MXD
CAMBRIDGE, MA

**INFILL DEVELOPMENT
CONCEPT PLAN**

**AMENDMENT 2
RESPONSE TO COMMENTS**

NOV 5 2021
SASAKI

R.3.2.1 FIG. 3

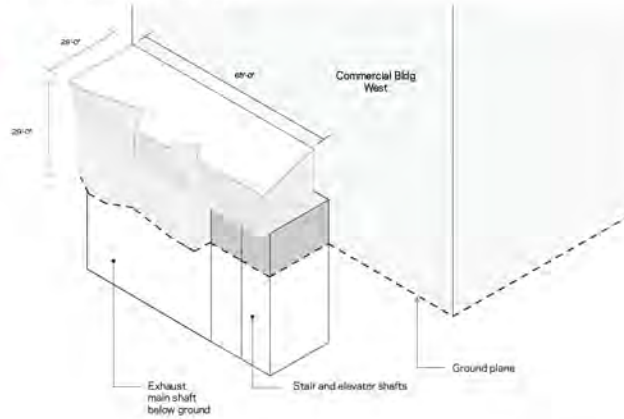
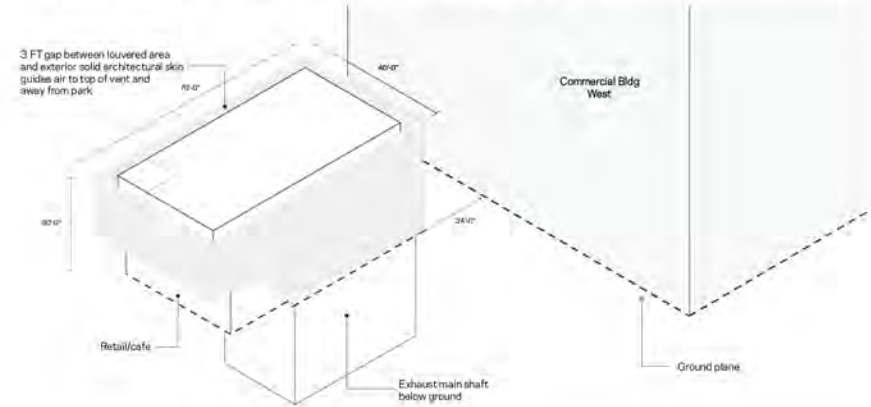
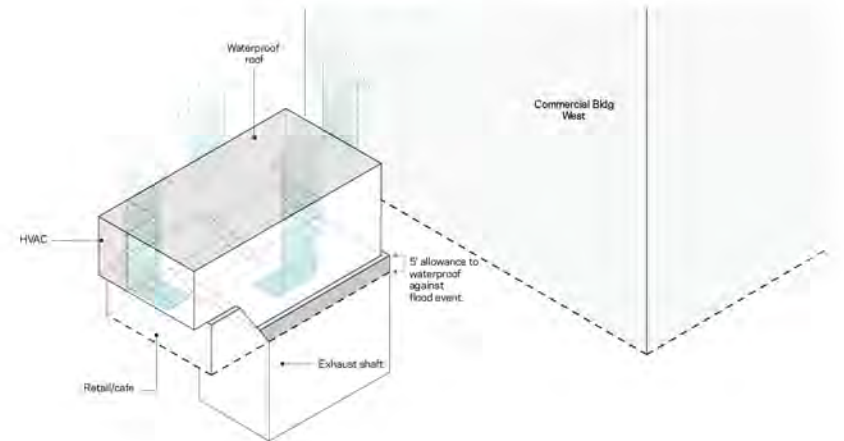
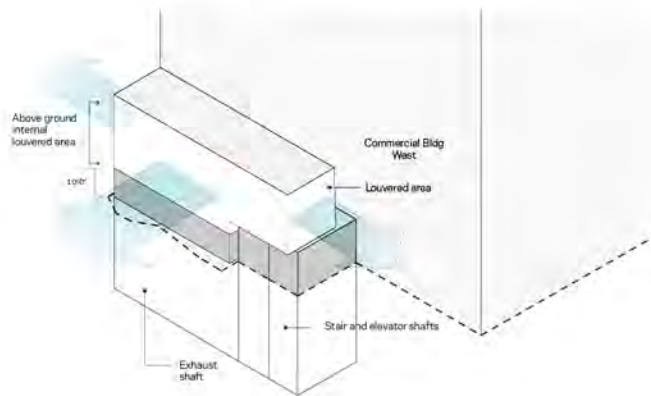
The Applicant received comments requesting additional information on the required ventilation stacks within Center Plaza for the Eversource substation.

Option not longer feasible because exhaust air would be too close to commercial building facade openings and terraces

R.5.1 FIG. 1

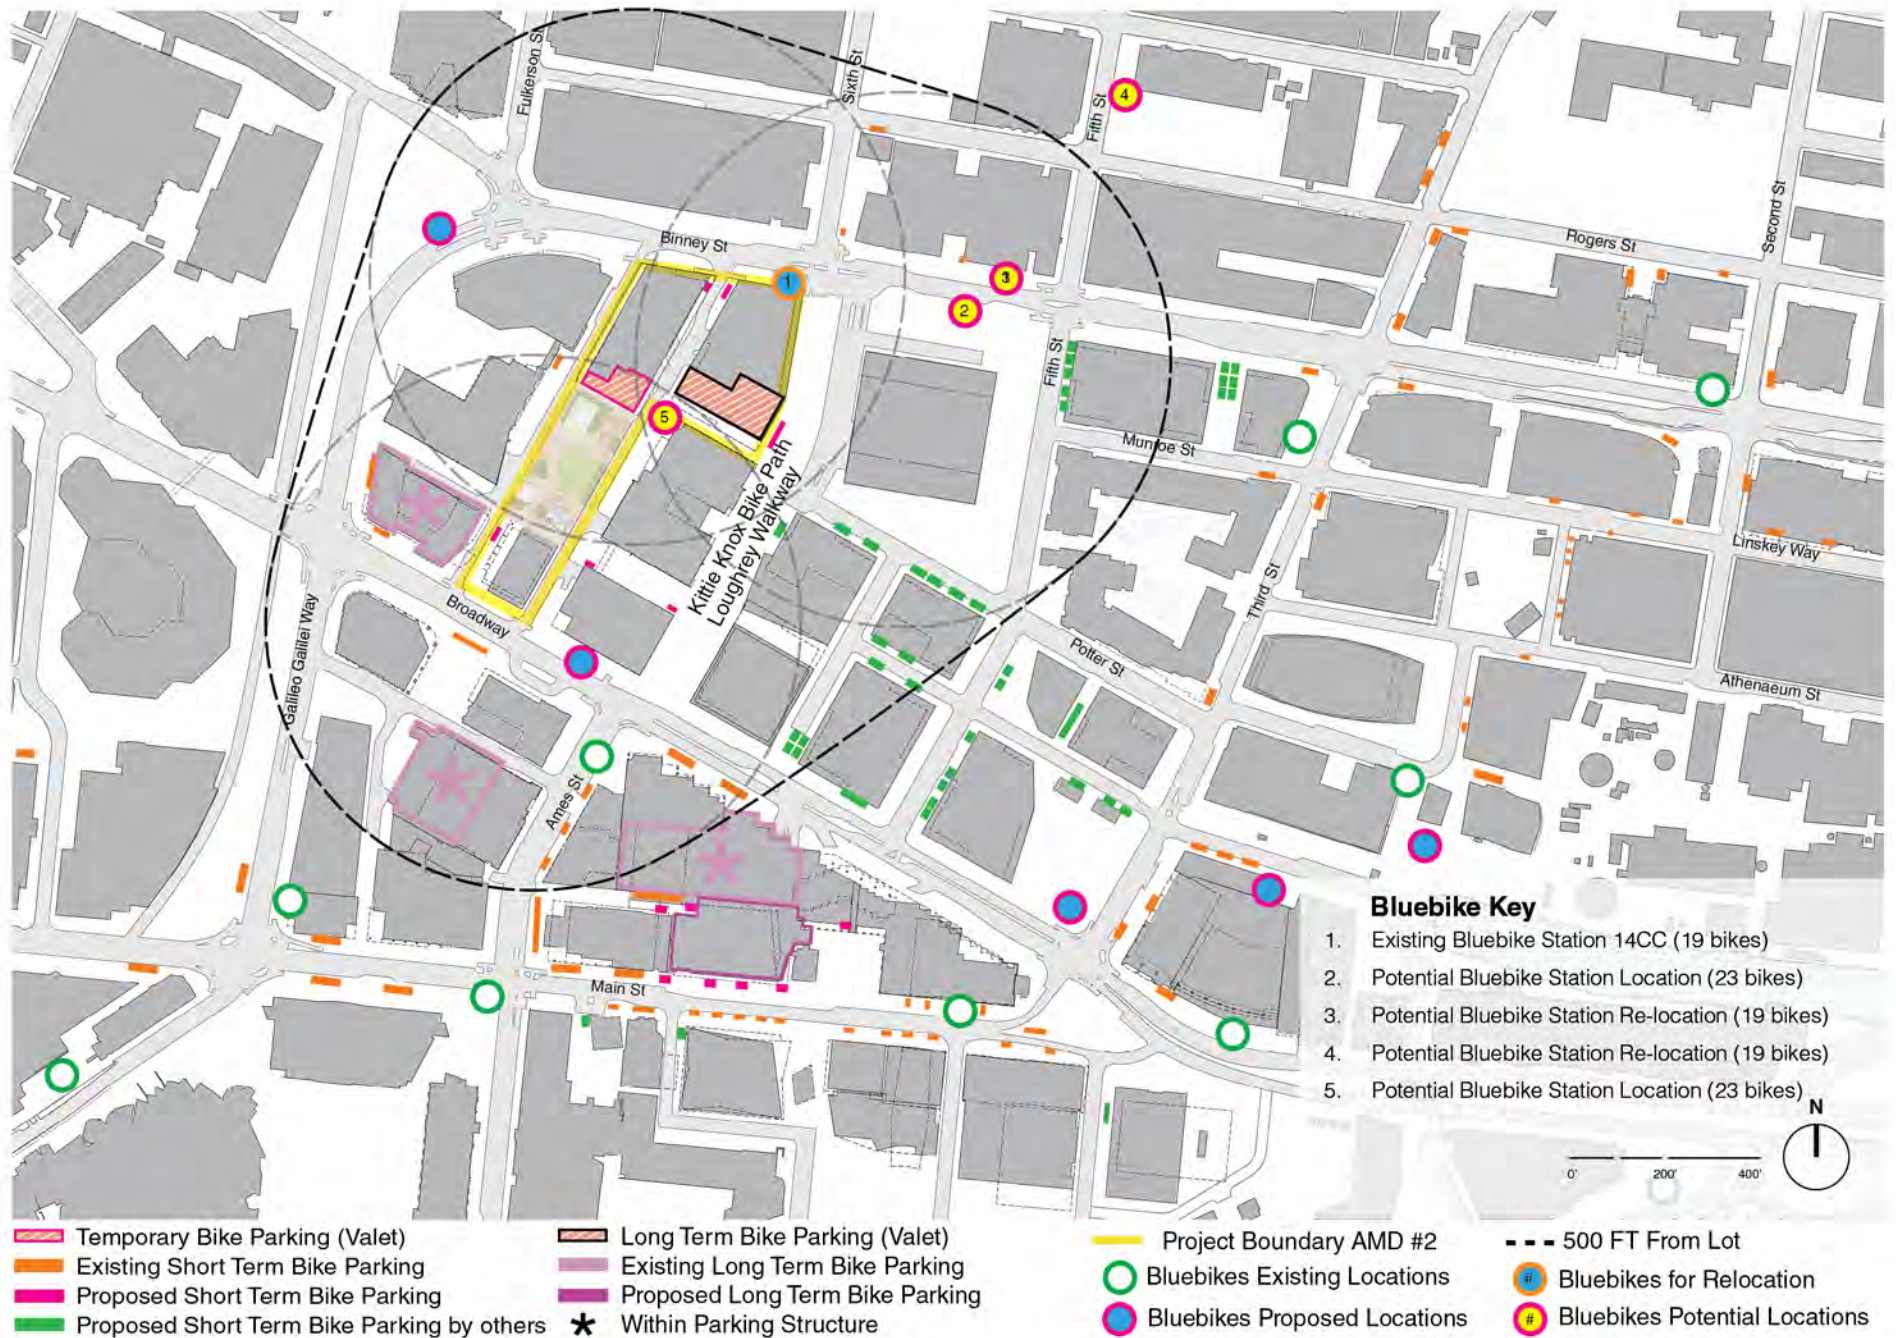
The Applicant received comments requesting additional information on the proposed bicycle valet service.

The Applicant is proposing to address bicycle parking needs via a deliberate blend of strategies permitted under the MXD Zoning Amendment adopted on February 23, 2021. The centerpiece of the Applicant's long-term bicycle parking strategy consists of a new bicycle valet facility, but also includes the provision of both long and short-term traditional self-park racks, as well as one new 23 dock BlueBikes bike share rack (the existing 19 dock Station at 250 Binney Street will be relocated). Refer to R.5.1 FIG.1 - FIG.2 for exhibits providing an overview of campus bicycle parking.

R.6.1 FIG. 1

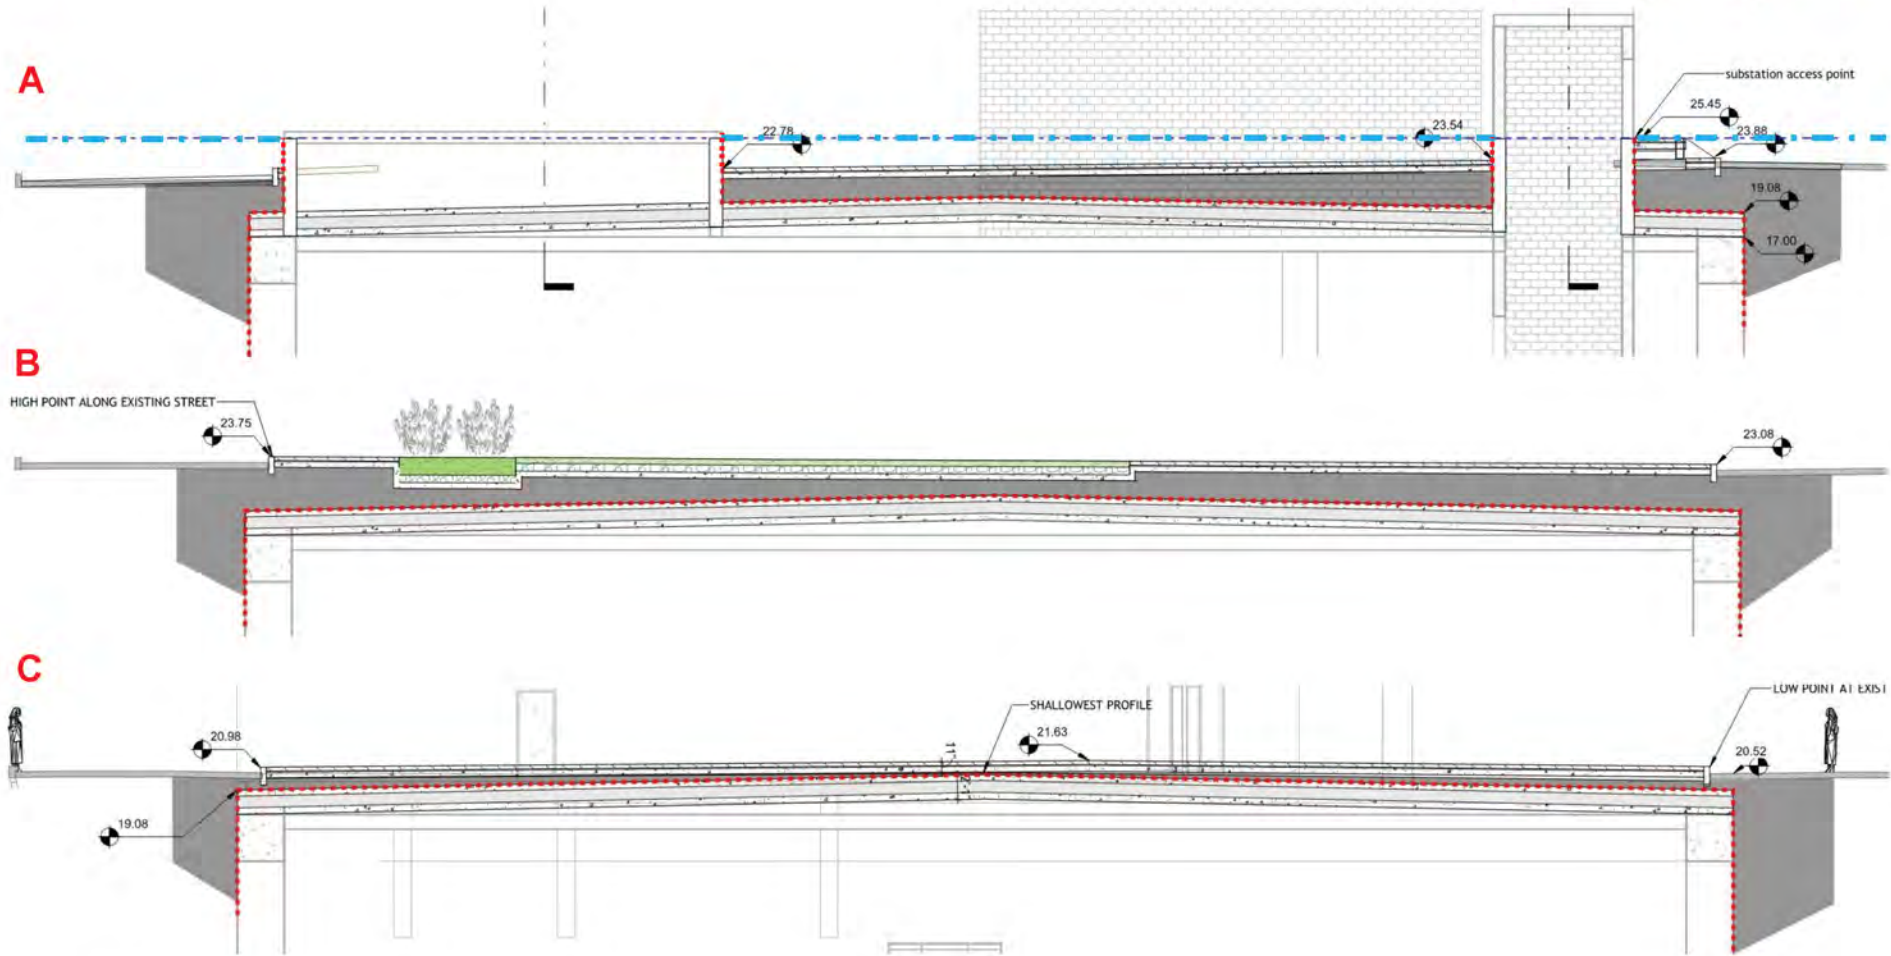
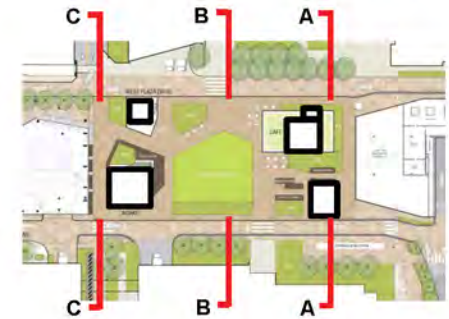
The Applicant received comments requesting additional information on proposed resilience measures for the substation, and how those measures may influence the design of the Center Plaza.

Beginning with the substation and Center Plaza, the Applicant in this instance is proposing to rely upon several distinct lines of defense congruent with existing infrastructure and key features of the public realm. The Applicant proposes that all vertical penetrations in the Center Plaza/substation roof should be raised to an elevation of 25.45 feet so as to prevent water infiltration into the substation in the event of a 2070 100-year flood. Vertical elements impacted by this strategy include the exhaust and intake structures that provide ventilation for the substation facility, among others. The substation itself will also utilize a pitched “shed” roof structure to direct water around the substation vault slurry wall, reducing the likelihood of water infiltration from precipitation. Wrapped on top of this roof structure will be a layer of high-performance waterproofing to further buttress the substation vault’s ability to resist water infiltration. These measures, coupled with the substation vault’s structure and slurry wall design—are anticipated to ensure the long-term viability of the electrical substation.
